From: Rob Biersteker <rob.biersteker@luvata.com>
Sent: Thursday, May 23, 2019 9:35 AM
To: Borski, Jennifer - DNR; Hecker, Michael; Mike Boozer
Cc: Hammerton, JP; Wayne Fassbender; Sam Edwards (sam.edwards@luvata.com)
Subject: Re: DNR Comments on Public Participation Plan for Appleton Wire (Former), BRRTS #02-45-000015
Attachments: Luvata Appleton - Response to J. Borski - 5.23.2019 15087432-v2.docx; Appleton SWPPP.pdf

From: "Borski, Jennifer - DNR" <Jennifer.Borski@wisconsin.gov>
To: "Hammerton, JP" <JP.Hammerton@albint.com>
Cc: Wayne Fassbender <wfassbender@enviroforensics.com>, "Sam Edwards (sam.edwards@luvata.com)" <sam.edwards@luvata.com>, "rob.biersteker@luvata.com" <rob.biersteker@luvata.com>
Date: 05/21/2019 04:09 PM
Subject: DNR Comments on Public Participation Plan for Appleton Wire (Former), BRRTS #02-45-000015

STORM WATER BASE DRAINAGE MAP
 LUVATA APPLETON, LLC
 APPLETON, WISCONSIN

STORM WATER BASE DRAINAGE MAP
SCALE: 1" = 60'-0"

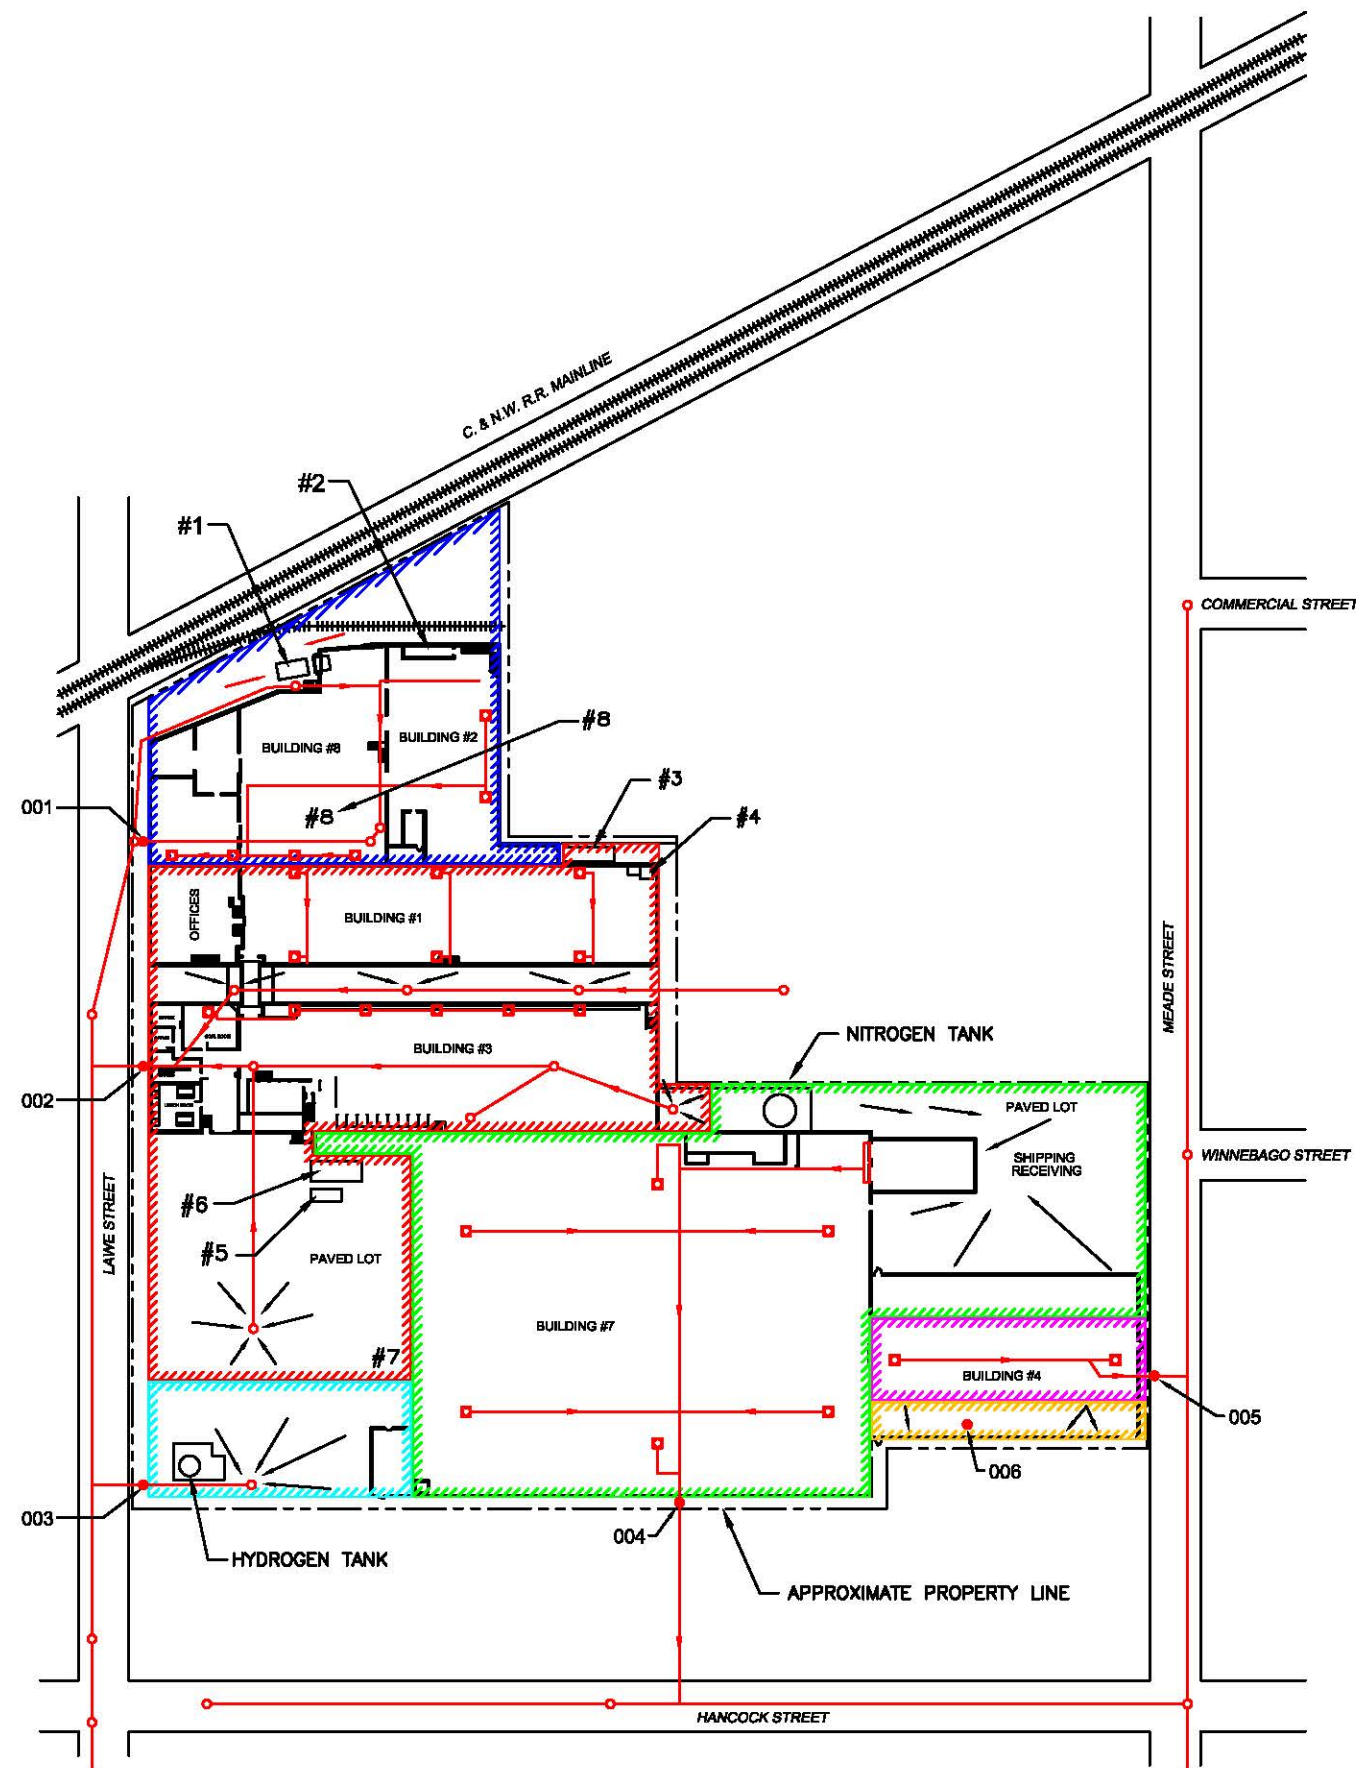
Luvata's SWPPP identifies six (6) different outfalls of concern (Please see attached scaled diagram). Of these six outfalls, Outfalls No. 5 and 6, which include the loading dock storm drain, are of concern for potential chromium releases as a result of remedial and trucking activities associated with Albany's RAP. As such, the protection of these outfalls need to be addressed to ensure compliance from an industrial storm water perspective, with some direction as to whether Luvata will be granted a waiver or an exemption from addressing SWPPP requirements as they relate to this project due to the remedial nature, or if it will be required to amend its SWPPP during the work period, and conduct additional monitoring of these outfalls for potential chromium contaminated discharges. If your note was meant to indicate that such activities will be exempt from Luvata's compliance perspective, apologies for any confusion. However, if that is still unclear, we would appreciate further guidance on the matter.

E. Where is the storm water inlet(s) from the west parking lot?

The open-grate manhole is located in the middle of the west parking lot. This would necessarily be captured in the middle of the proposed temporary structure. Please see the attached diagram taken from the Facility's SWPPP, which is scaled to size. Should a temporary warehouse ultimately be determined to be a feasible option after considering all of the other matters that need to be addressed, storm water drainage controls for this area will need to be implemented as well.
